**Flood Control Project Maintenance
Levee Inspections**

Fall 2019 Levee Maintenance Deficiency Summary Report

Reclamation District No. 0556 Upper Andrus

Levee Inspection Report By Mile - Fall 2019

Photo 1 of 3 : UCIP_FA_2019_45663_74180.jpg

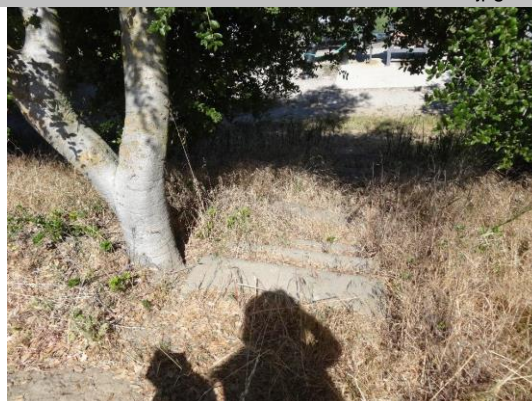
Comment Code						
Inspector Comment						
DS_ID:20821 FS_ID:45663 EP_NO: 5548 Repair Type: Non-Urgent Crossing Status: Found UCIP Comments: Dense vegetation prevents inspection of WS slope. FIELD_STRUCT_DESC: 12-inch steel irrigation discharge pipe through the levee, 5 feet below the crown. 1.25-inch electrical conduit through the levee at the same location. Pump on the waterside (WS). Concrete steps on the landside (LS) slope. Cuts in pavement visible at the crossing. (Plans to install a pump with a 12-inch discharge pipe and one electrical conduit through the levee authorized under Permit No. 5548, 1966 - George K. Adams). [Additional Reference(s): DWR Levee Log]. FS Date: 5/13/2015

Concrete steps on LS slope.

Photo 1 of 1 : FA_2019_RD0556_18_24_20190826_00006.jpg

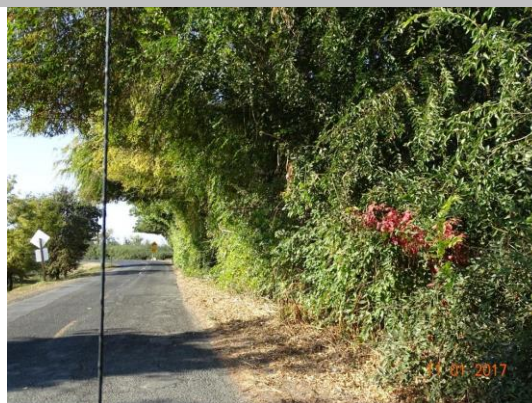
LM Start	0.87	Rating **	U	Issue No.	24
LM End	0.87	Issue Type +	En	Location *	LS
Category	Earthen Levee			GPS Latitude/Longitude	
				Start	End
Item	Vegetation			38.228820 °	38.228820 °
				-121.525853 °	-121.525853 °
DWR ID	DWR_RD0556_01_f_2017_24				
Comment Code					
V6 : Landscaping					
Inspector Comment

Trim/thin landscaping to allow inspection and access to levee slope and toe.

Photo 1 of 1 : FA_2019_RD0556_19_25_20190826_00010.jpg

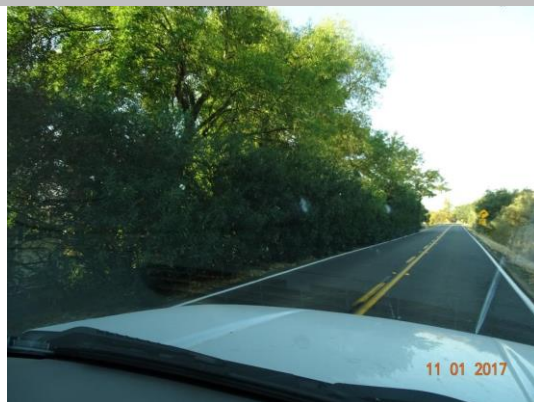
LM Start	0.55	Rating **	U	Issue No.	25
LM End	0.55	Issue Type +	En	Location *	LS
Category	Earthen Levee			GPS Latitude/Longitude	
				Start	End
Item	Vegetation			38.237810°	38.237810°
				-121.528182°	-121.528182°
DWR ID	DWR_RD0556_02_f_2017_25				
Comment Code					
V6 : Landscaping					
Inspector Comment					
Trim/thin oleanders on the landside of the levee.

View of oleanders on the landside of the levee.

Photo 1 of 1 : FA_2019_RD0556_19_66_20191107_00083.jpg

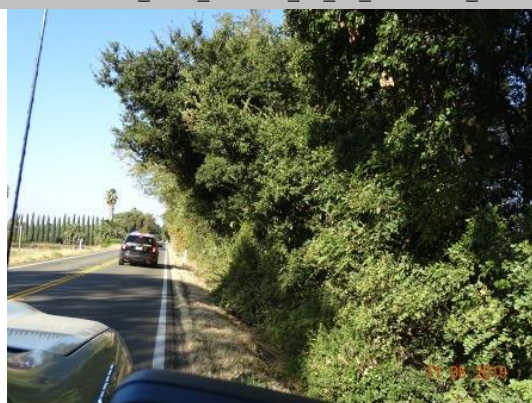
LM Start	1.37	Rating **	U	Issue No.	66
LM End	1.43	Issue Type +	Ma	Location *	WS
Category	Earthen Levee			GPS Latitude/Longitude	
				Start	End
Item	Trim / Thin Trees			38.239888 °	38.240080 °
				-121.542833 °	-121.543942 °
DWR ID	DWR_RD0556_02_f_2019_66				
Comment Code					
T1 : Trim trees to at least five feet above ground level.					
Inspector Comment

View looking downstream at thick trees on the waterside slope (Fall 2019).

Photo 1 of 1 : FA_2019_RD0556_19_16_20190826_00004.jpg

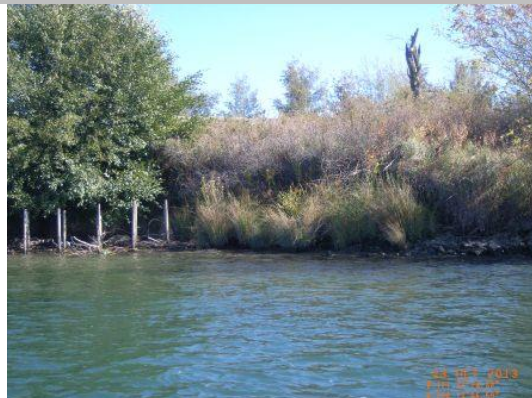
LM Start	3.58	Rating **	M	Issue No.	16
LM End	3.64	Issue Type +	Ma	Location *	WS
Category	Supplemental			GPS Latitude/Longitude	
				Start	End
Item	2017 USACE Erosion Survey			38.218951 °	38.218104 °
				-121.556689 °	-121.556819 °
DWR ID	DWR_RD0556_02_f_2018_16				
Comment Code					
Inspector Comment					
2017 Site ID: SAC 22.7 L					
Status: Eroding					
2017 Field Notes: Minor new erosion at toe.					
Site History: 1997 - Scallops into berm and very close to levee toe.					
2005 - Brush boxes present. 2011 - New toe scour and freshly fallen tree. 2012 - New tree popout has taken significant portion of soil out of the levee.

Photo 1 of 3 : UCIP_FA_2019_12545_20310.jpg

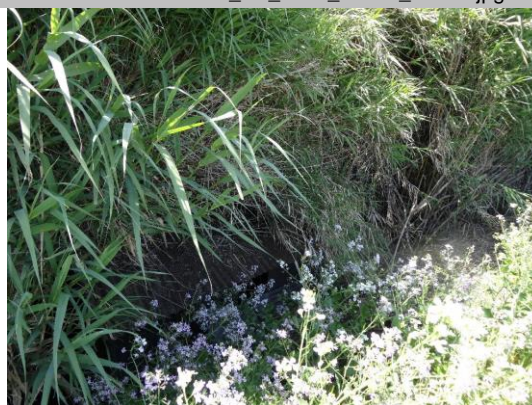
Comment Code						
Inspector Comment						
DS_ID:20865 FS_ID:12545 EP_NO: 11194 Repair Type: Non-Urgent Crossing Status: Found UCIP Comments: - CMP riser found abandoned on LS slope. Due to dense vegetation siphon breaker could not be found.- Dense vegetation on both sides of the levee.- Oil leaks from pump set. FIELD_STRUCT_DESC: 8-inch steel irrigation discharge pipe through the levee, 6.7 feet below the crown. Pump and gate valve in a pump house on the waterside (WS) slope. Siphon breaker on the landside (LS) slope. (Retention of an 8-inch pipe through the levee, 6.7 feet below the crown, a pump and a gate valve in a pump house on the WS slope, and a siphon breaker on the LS slope authorized under Automatic Board Order (ABO) issued as Permit No. 11194, 1975 - Gerald E. and William M. Robinson, et al.). [Additional Reference(s): DWR Levee Log. USACE Sacramento O&M Manual 103, June 1954, (Station ""J"" 18+20), invert elevation 18 feet]. FS Date: 4/25/2013

WS- pump house not visible due to the dense vegetation.
